02-Sep-10

LETTER OF VIOLATION - Inspection

PEARL JORDAN No.003

SUMMIT RESOURCES inc.
PEARL JORDAN #3 AND T/B.
P 17-45-33E 30-04-20593

FLOWLINE LEAK 4' X 300' +/-

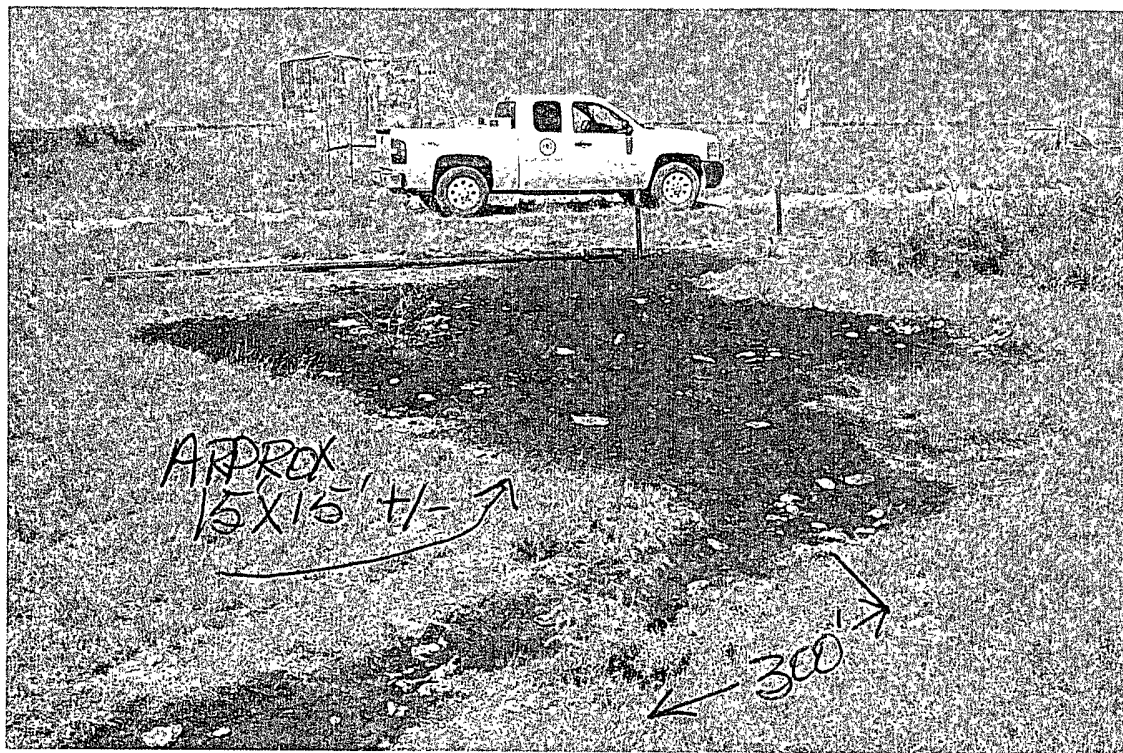
Comments on Inspection: FOLLOWUP ON COMPLAINT FROM WAYNE KINMAN-RANCHER IN REFERENCE TO FLOWLINE LEAK. NEED TO SUBMIT C-141 TO GEOFFREY LEKING (575-393-6161 EXT 113), HOBBS OCD DISTRICT 1 OFFICE FOR APPROVAL. RULE 19.15.29.8. ALSO NEED TO ADDRESS RELEASES AT TANK BATTERY. SEE PHOTOS-LOAD LINE, SUMP, AREA NORTHEAST OF HEATER TREATER AND AROUND WELLHEAD. SIGN AT WELL NEEDS CURRENT OPERATOR AND API#, RULE 19.15.16.8. NEED TO INSTALL SIGN AT TANK BATTERY, RULE 19.15.18.16. THIS IS 1ST LETTER OF NON-COMPLIANCE.
